PROJECT TITLE:
GARDEN HILL FIRST NATION +
WASAGAMACK FIRST NATION
HOUSING PROJECT
STREET NAME AND NUMBER
CITY, PROVINCE, POSTAL CODE

DRAWING TITLE:
FLOOR PLAN

A-1
SHEET 1 OUT OF 06

A-2
 SHEET 2 OUT OF 06

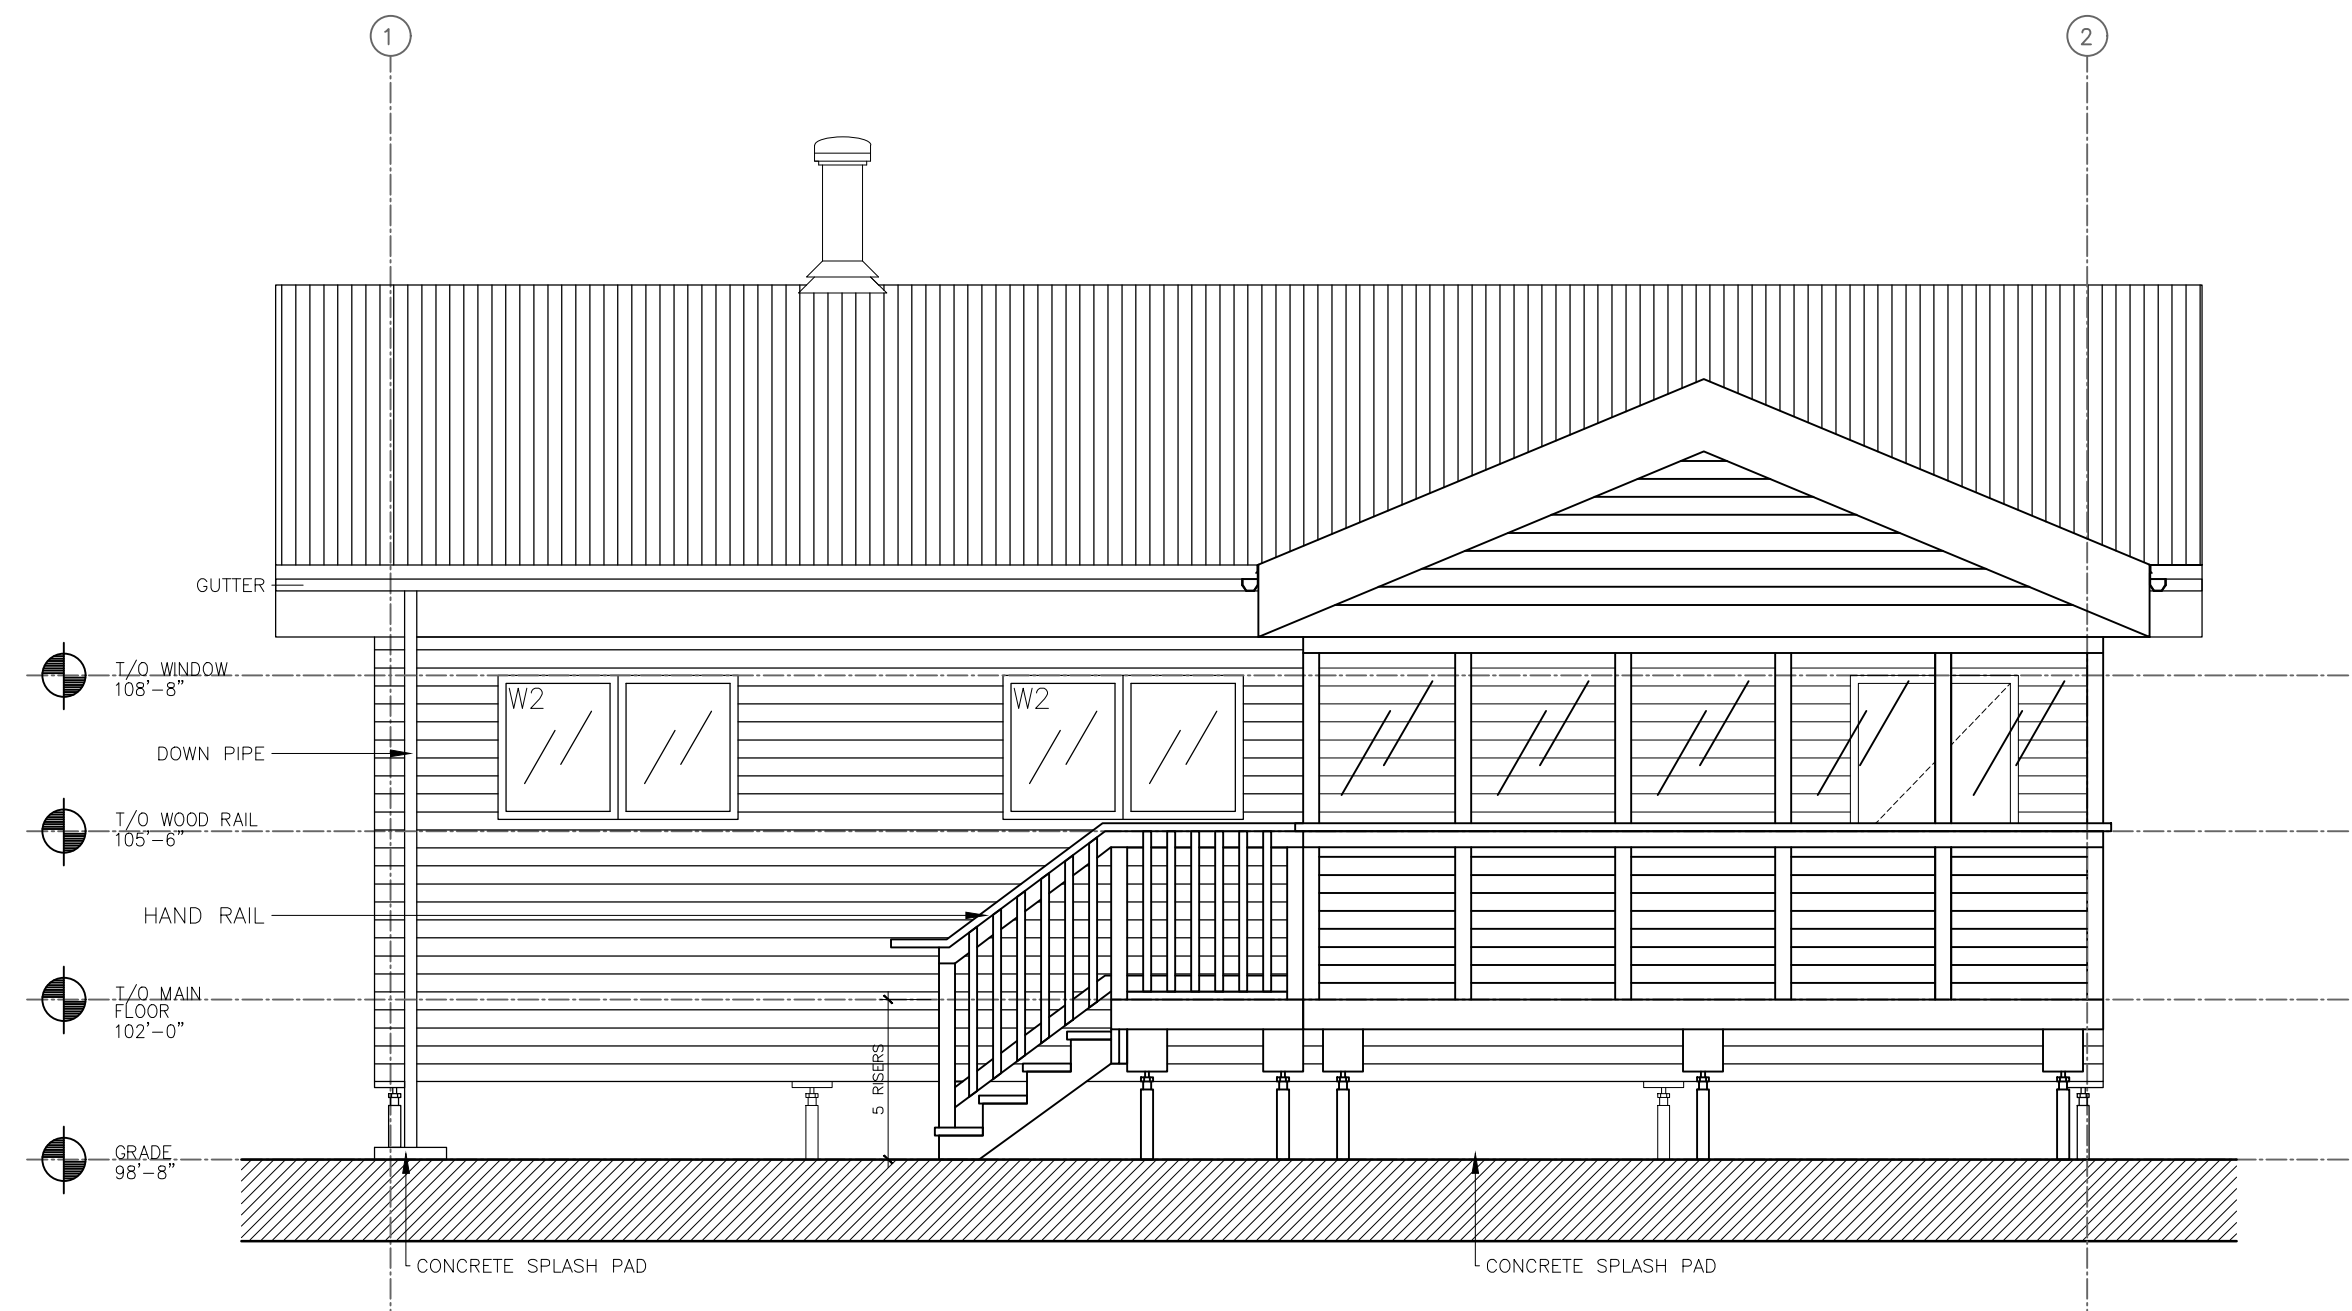
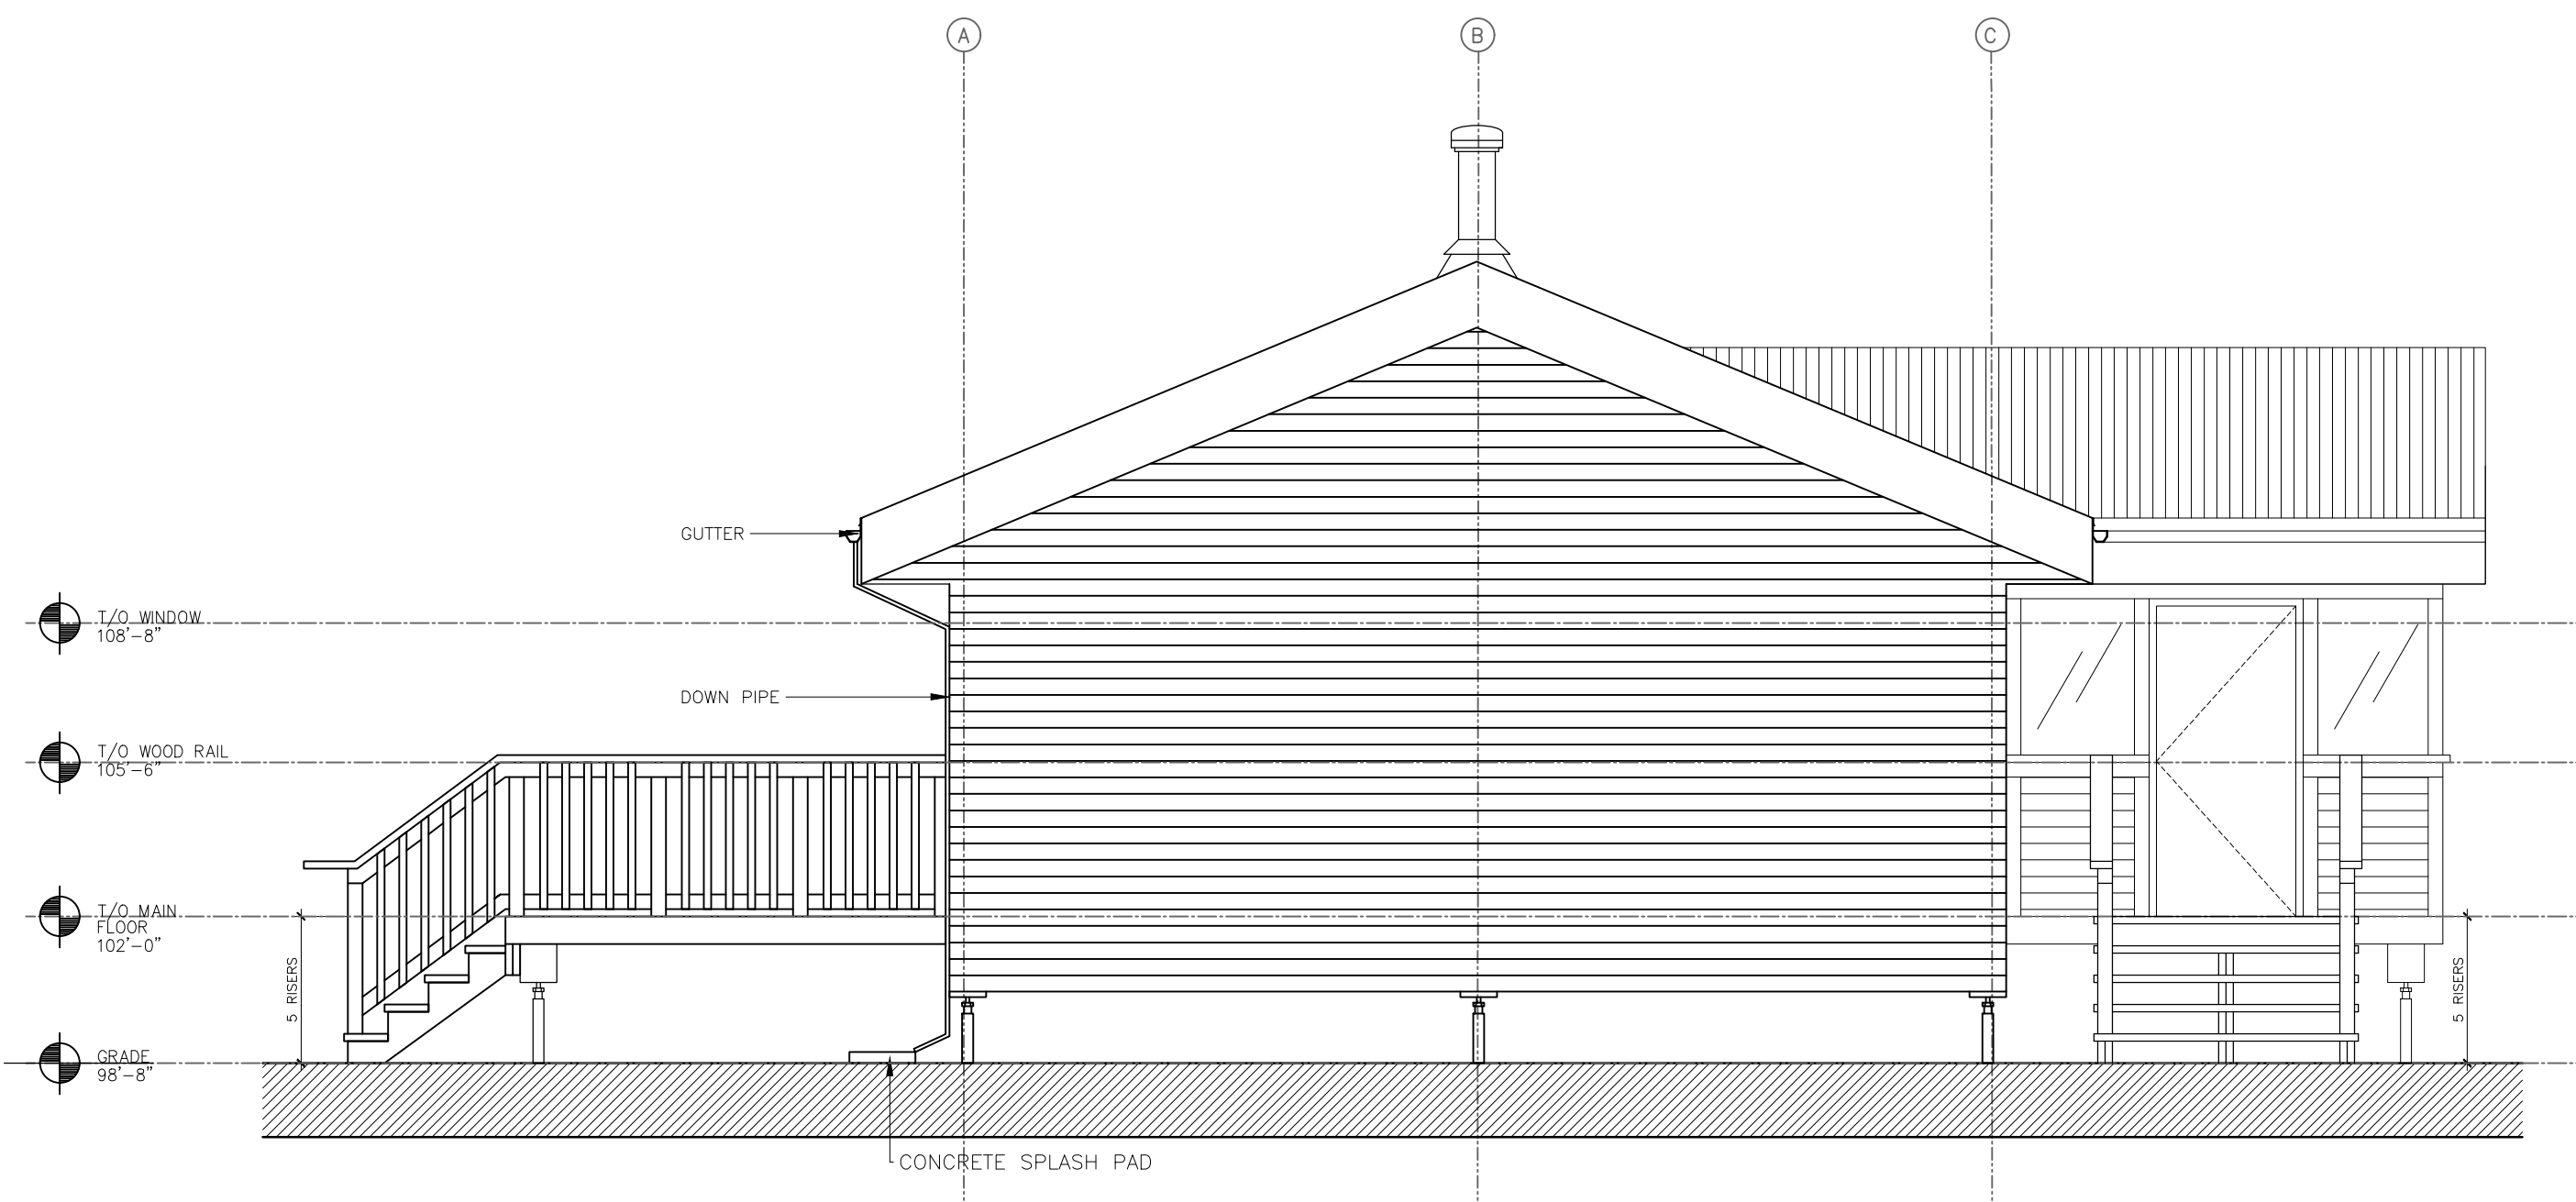
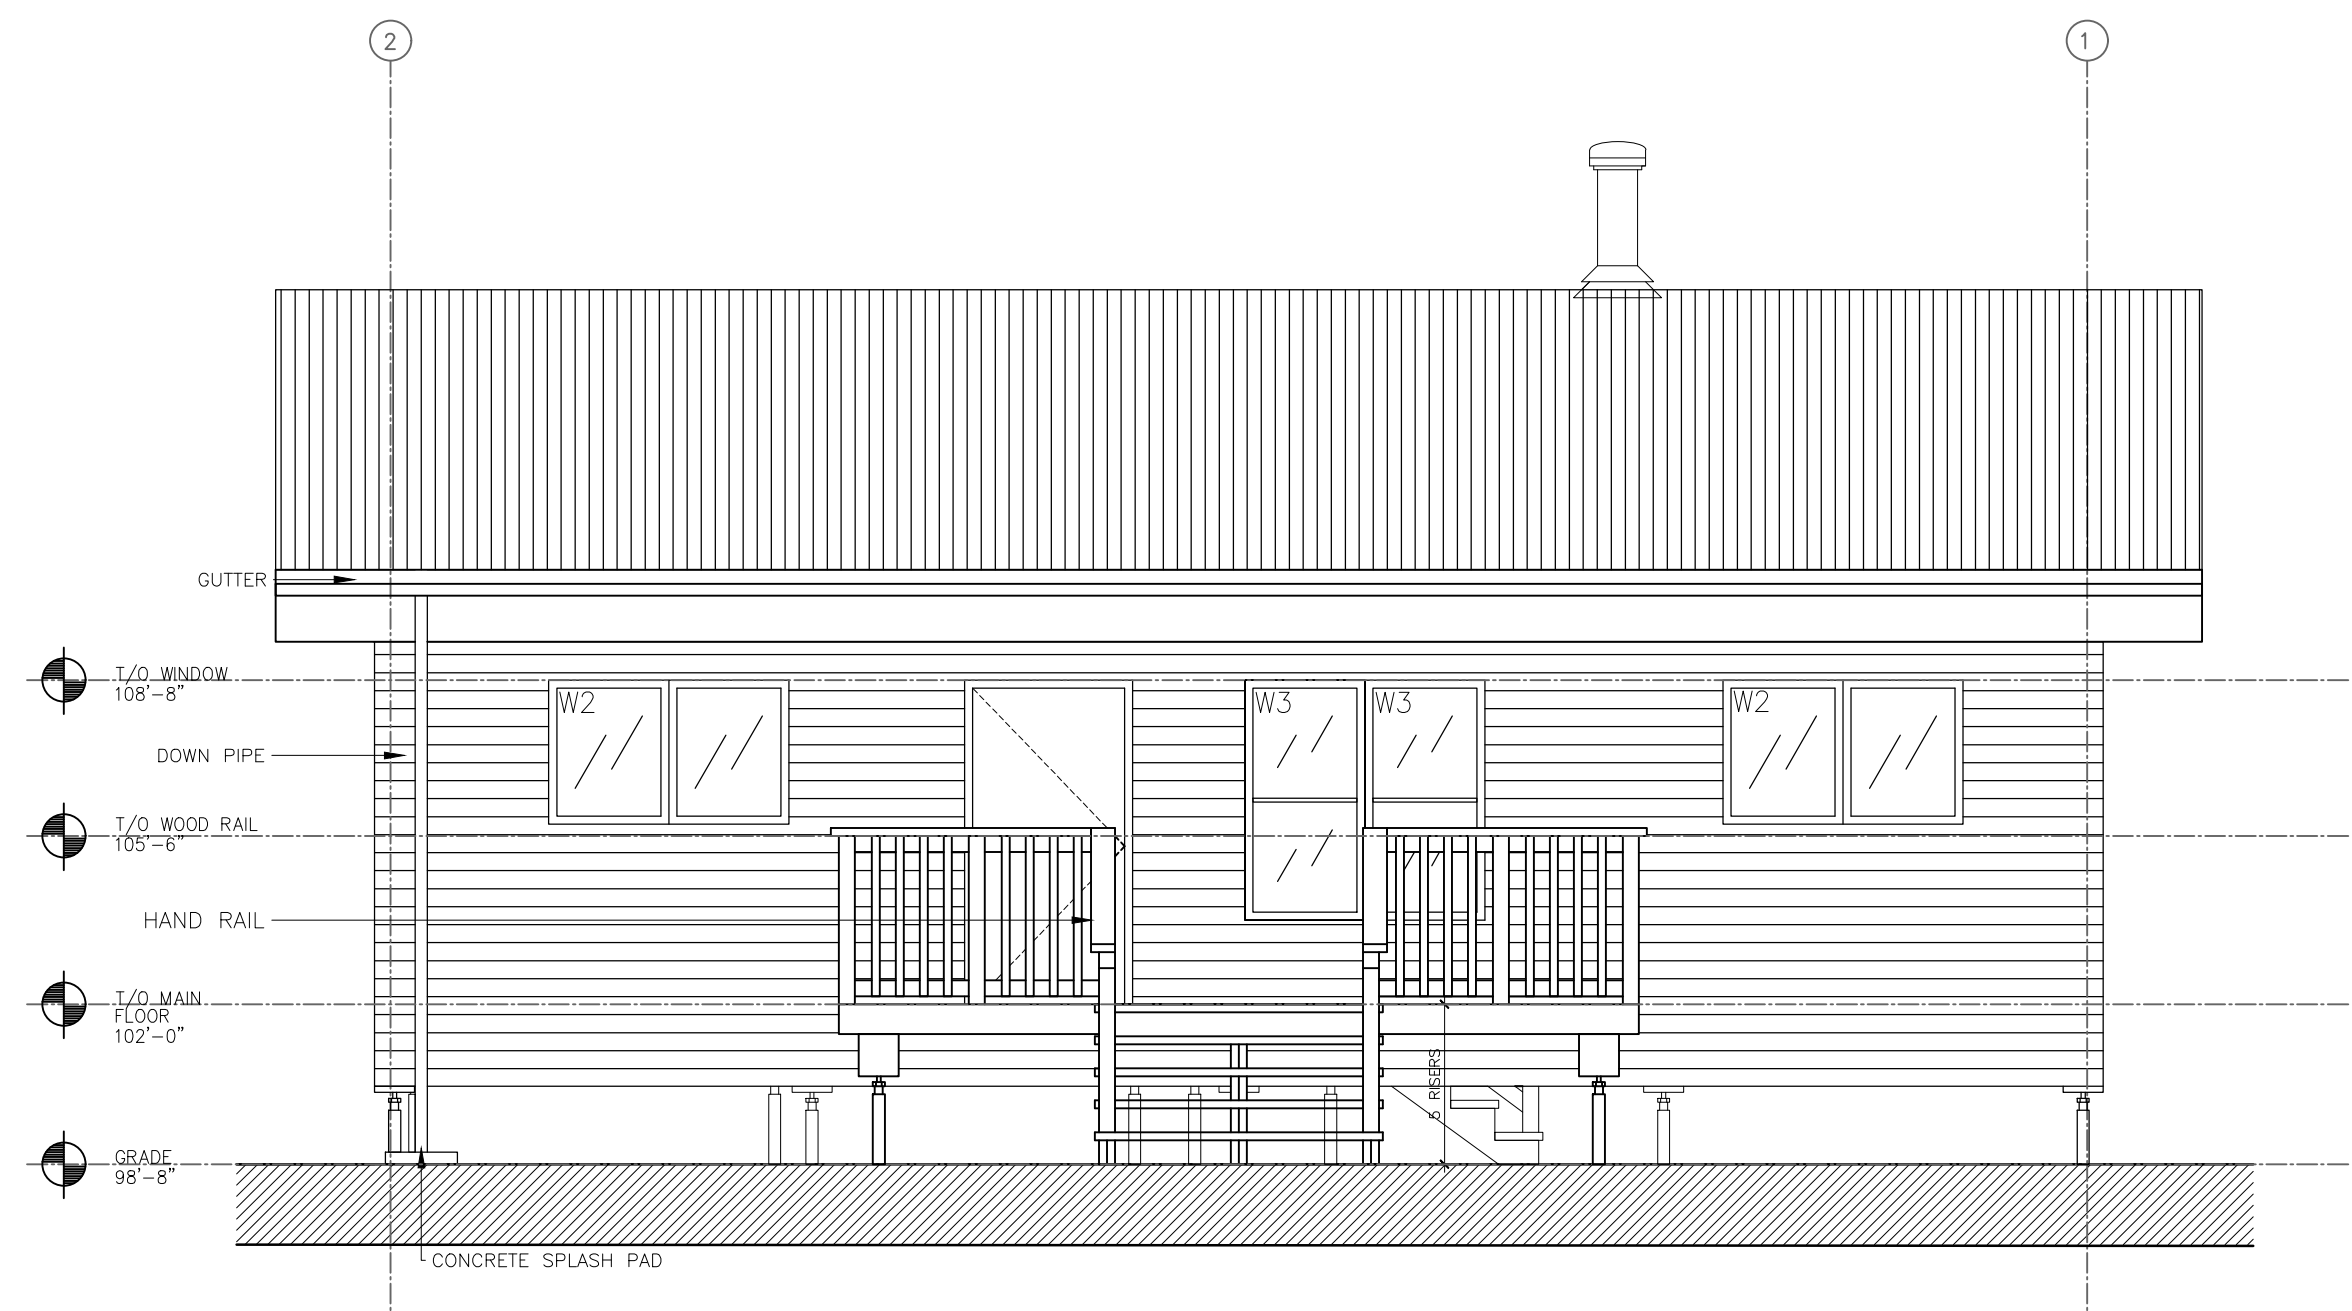
CONCERNS FOR REVIEW:
 1. CONSTRUCTION OF ENCLOSED VERTICAL CHASE
 I.1. ON PACKED GRAVEL?
 I.2. HOW TO INSULATE?
 2. STRUCTURAL LOAD CALCULATION MUST BE DONE. ADJUSTMENTS SHOULD BE MADE.
 3. ROOF AND CEILING ASSEMBLY.
 4. CHIMNEY AND MASONRY INTERIOR WALLS HAVE NOTE BEEN DETAILED.
 4.1. PLEASE TAKE A LOOK AND DETAIL AS APPROPRIATE.
